# **ITS3 activities in Bari**

## **BBM6**

# BBM6\_ThermalTestAssembly\_03-04-2024.stp

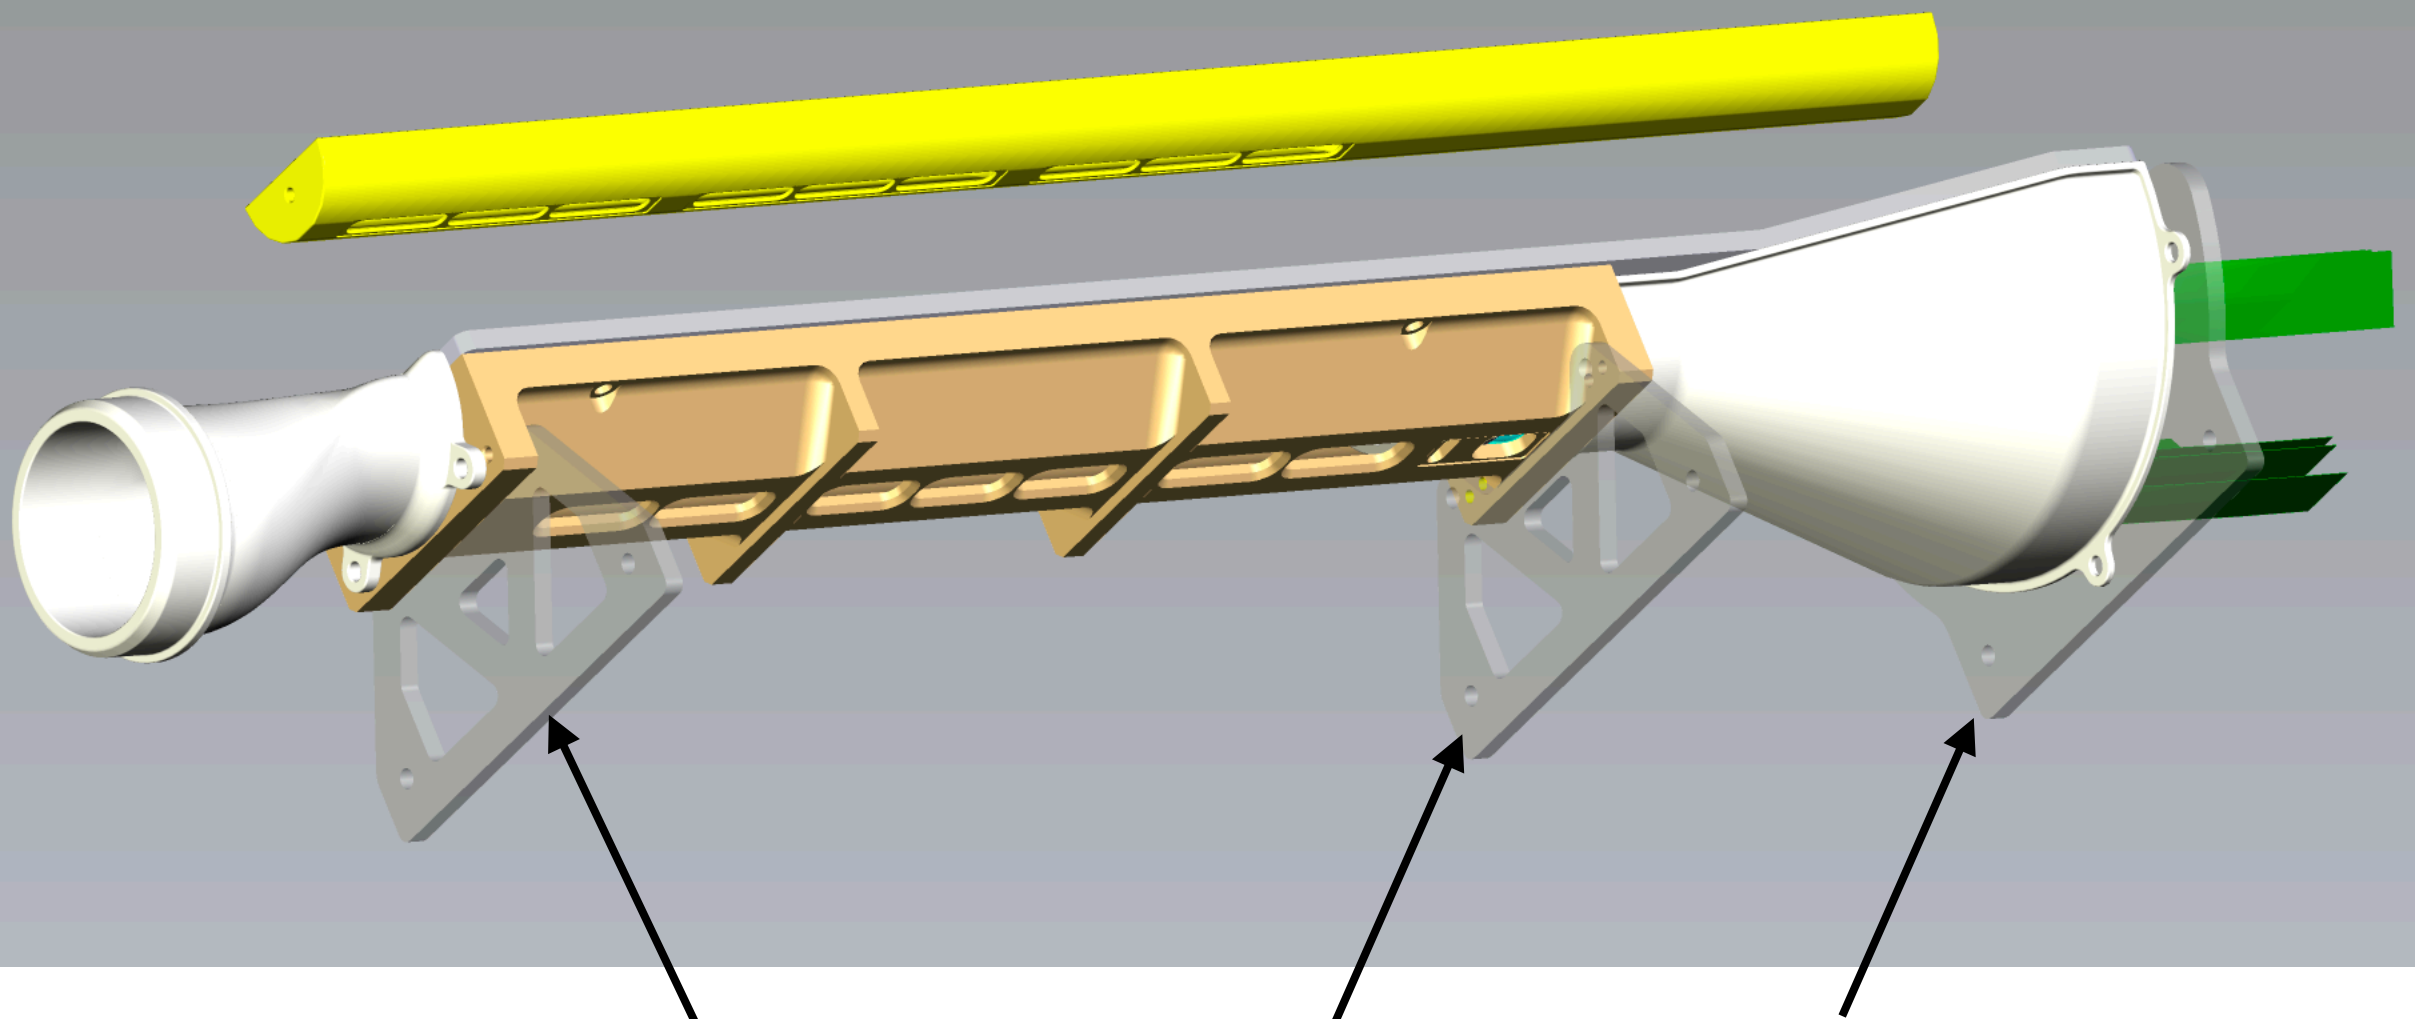
Which is usage of these two smaller windows?  
Should the position be modified?

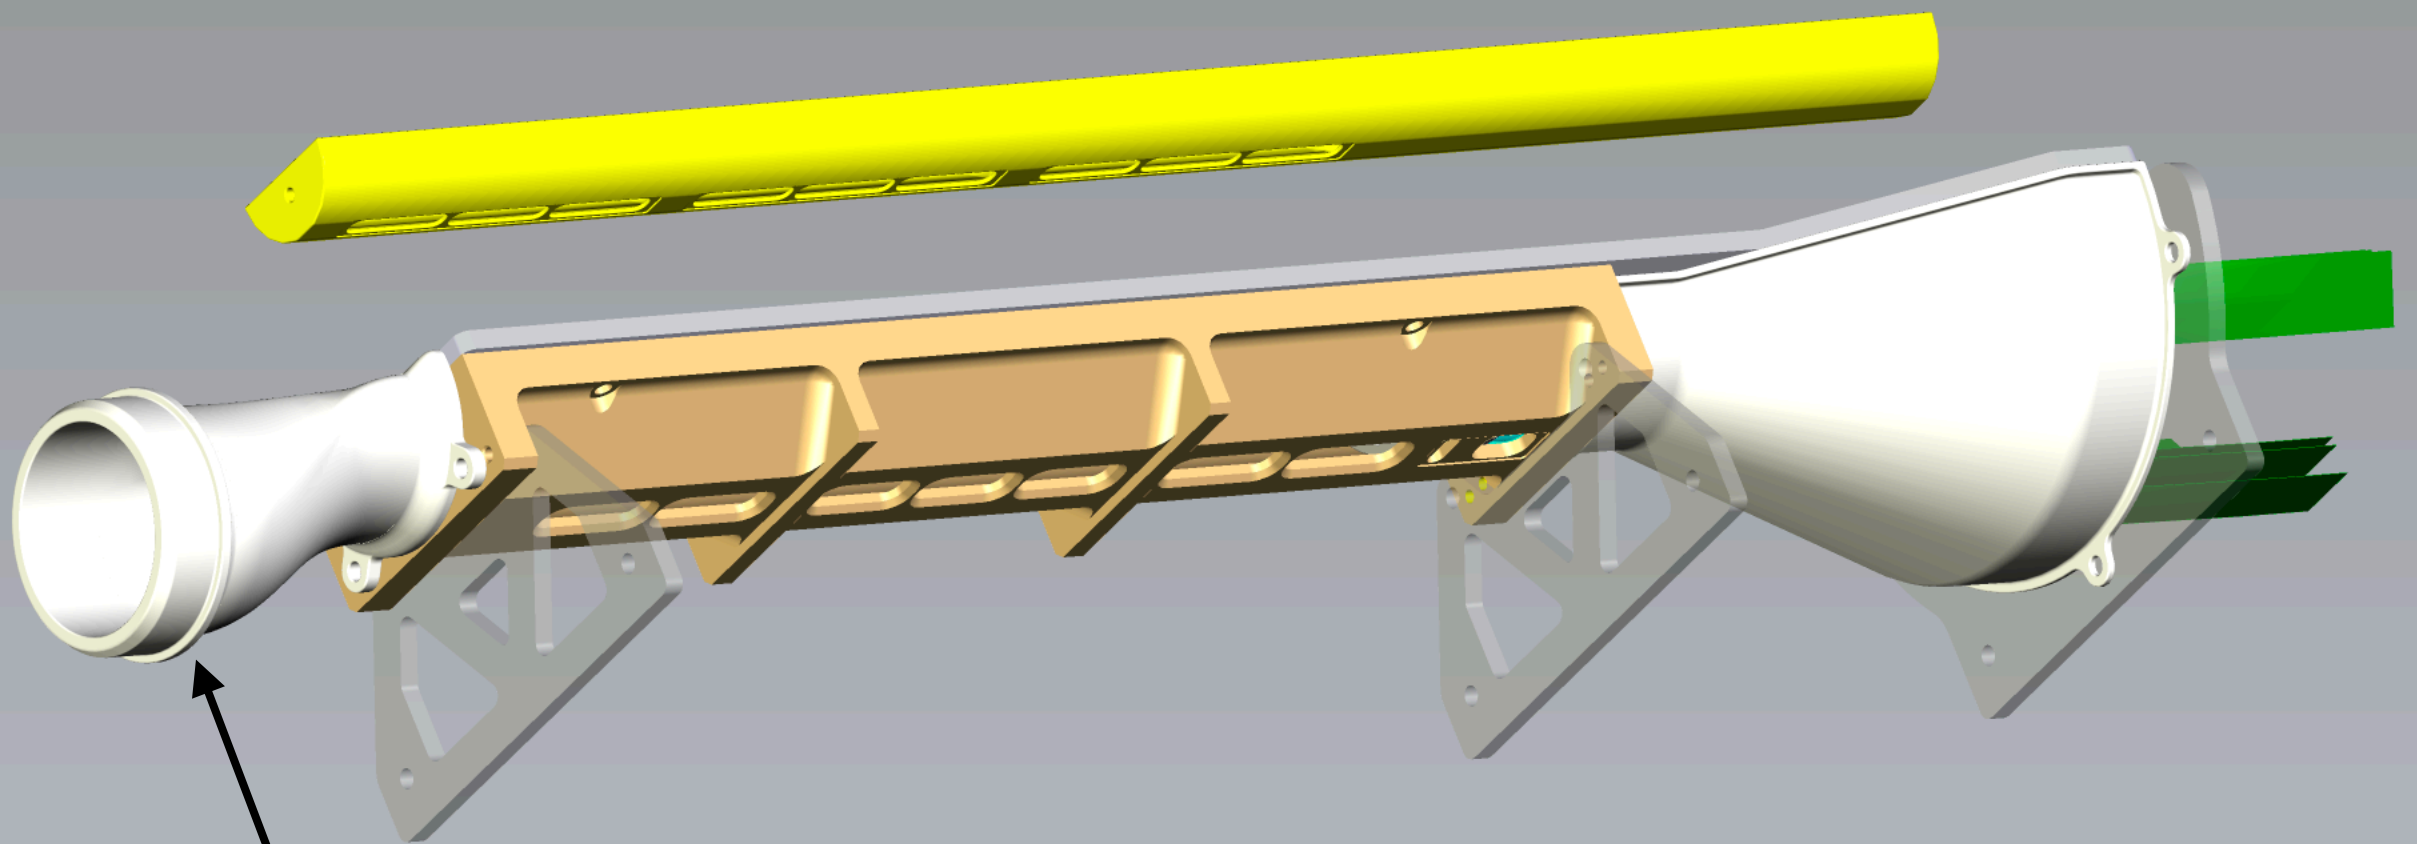
Are these supports used?  
The holes in the bottom part of the supports have a special meaning and should be kept?

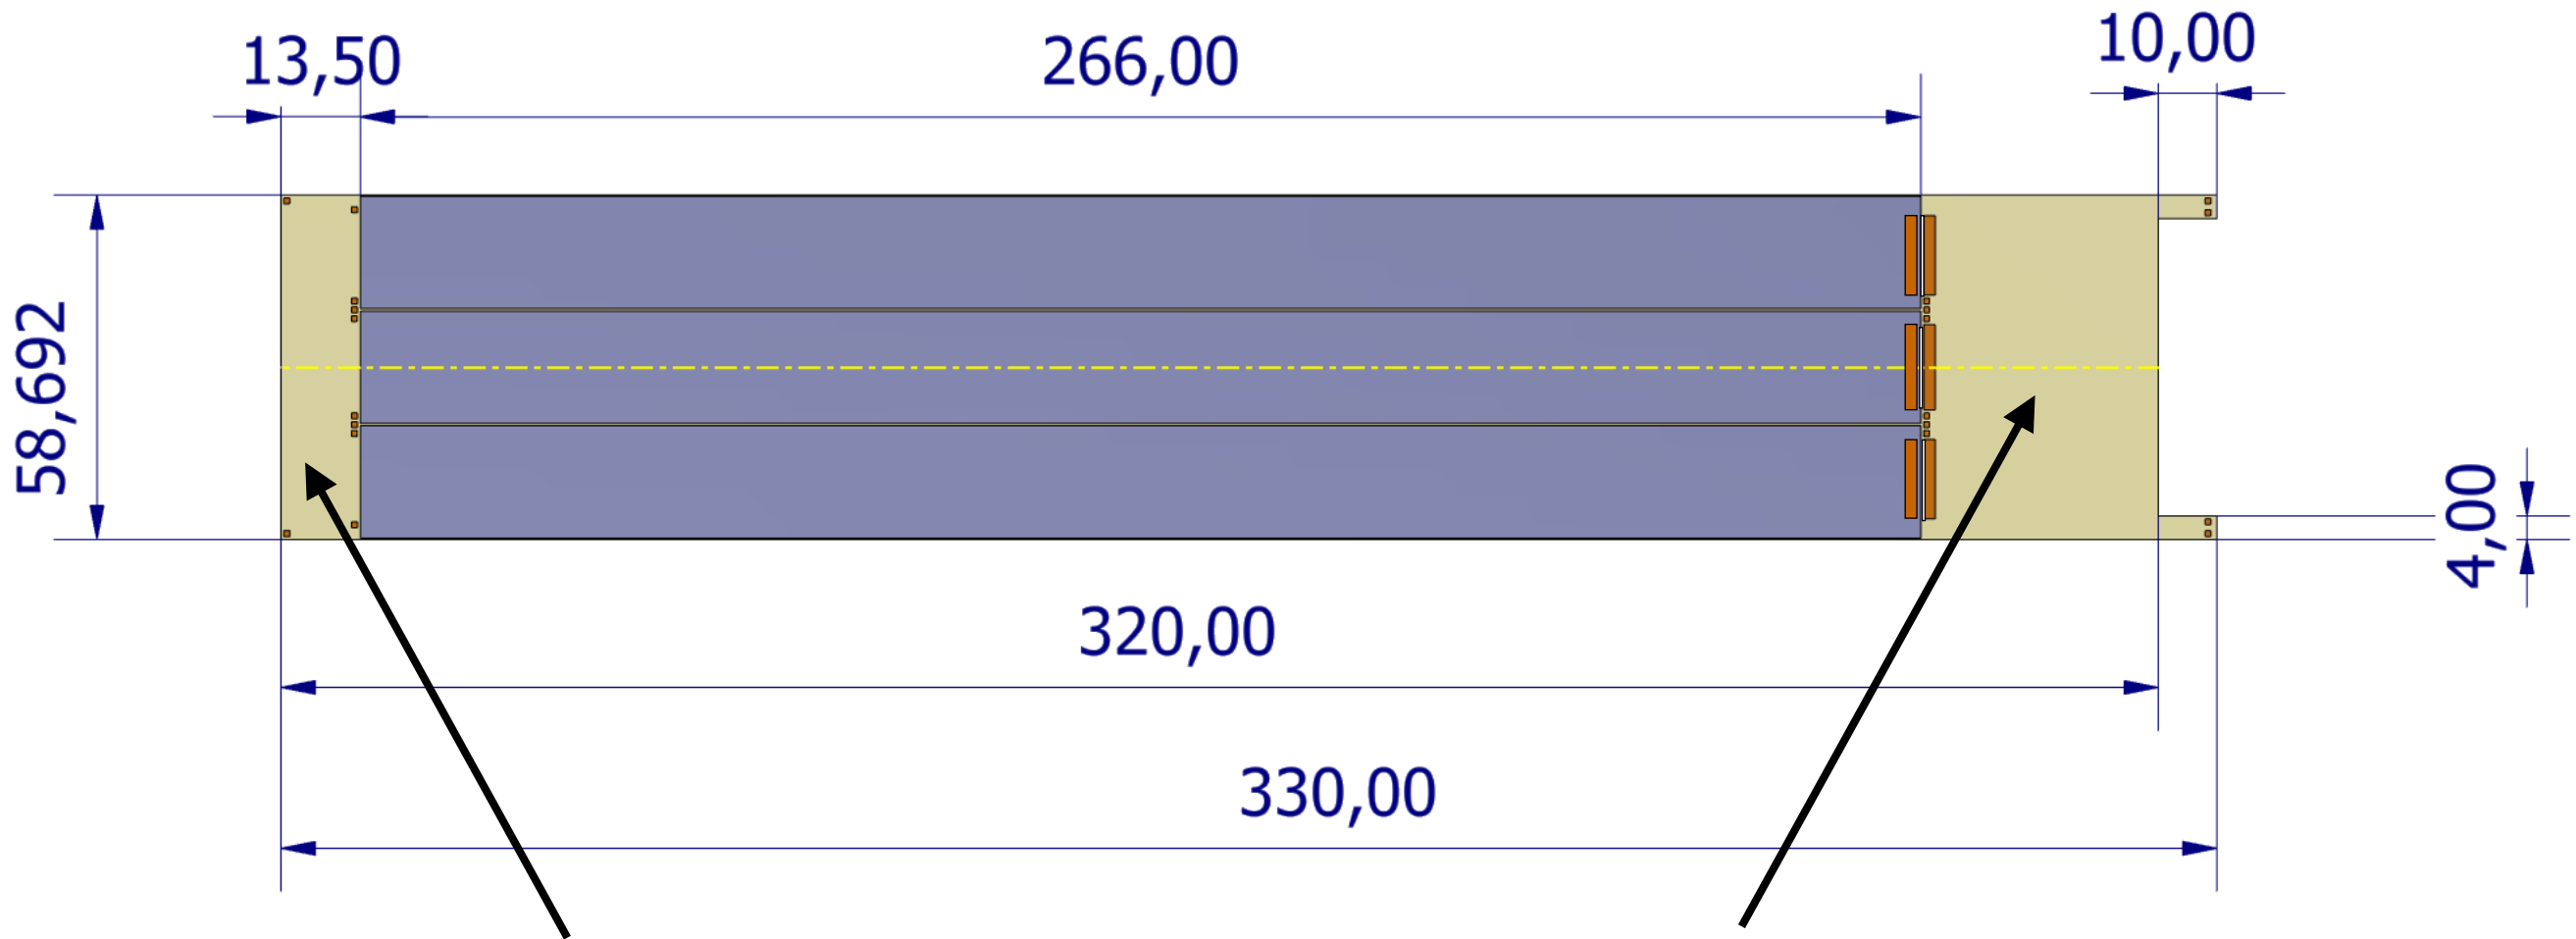
This needs to be redesigned.  
Should we do it or you prefer to implement special constrains?  
I assume that the diameter of the output should be kept.

Maybe question to Rui/Serge.
